Project: River Road Elementary School – Building and Site Construction
Title: Addendum No. 1
Contract No: CIP 410 307 001
Date: March 1, 2016
From: John Stapleton, PIVOT Architecture
To: Interested Bidders

This Addendum is available at <http://www.4j.lane.edu/bids/> and modifies the Project Manual, Specifications, and Drawings in accordance with the Invitation to Bid and the Instructions to Bidders as follows:

PROJECT #	133720	REVISION	
ISSUE DATE	2/12/16	DATE	ADD-1 - 03/02/2016
DRAWN	SC	CHECKED	PKC
E151

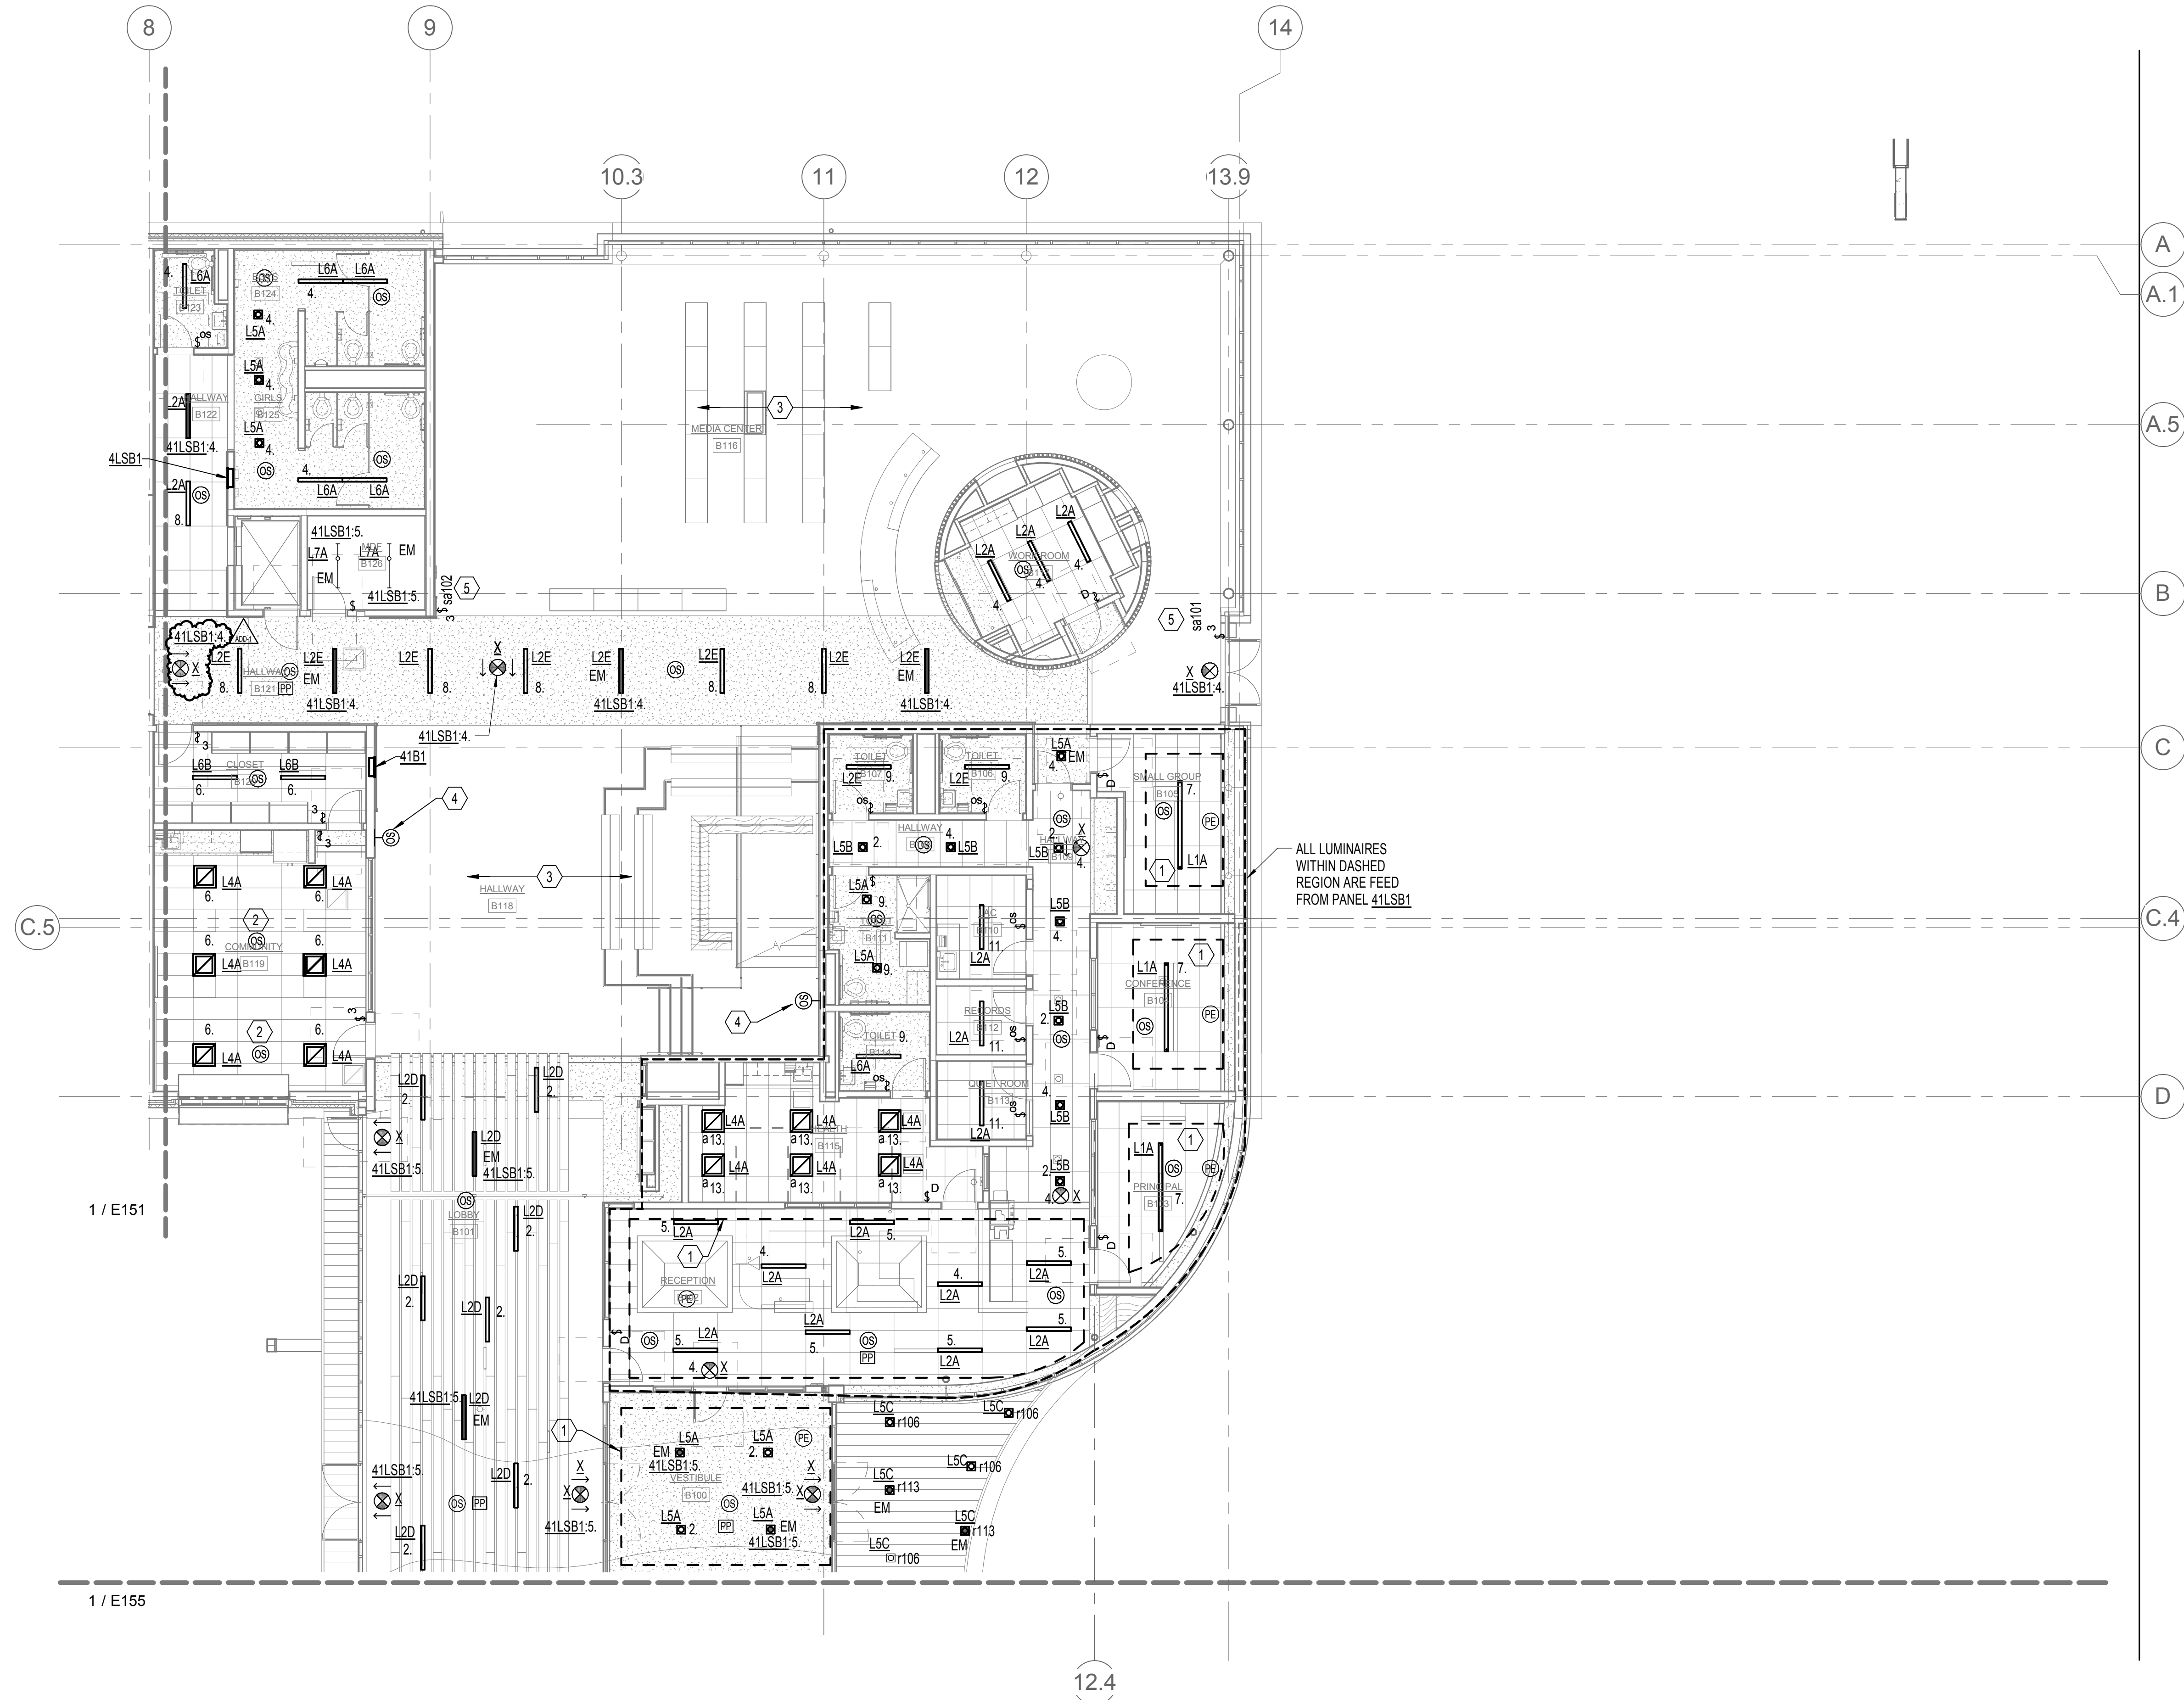
- 1-3-26 Sheet E151. Revised exit sign.
- 1-3-27 Sheet E153. Revised exit sign.
- 1-3-28 Sheet E155. Revised exit sign.
- 1-3-29 Sheet E161. Relocated classroom L1A/L1B luminaires to match reflected ceiling plan. Revised exit signs.
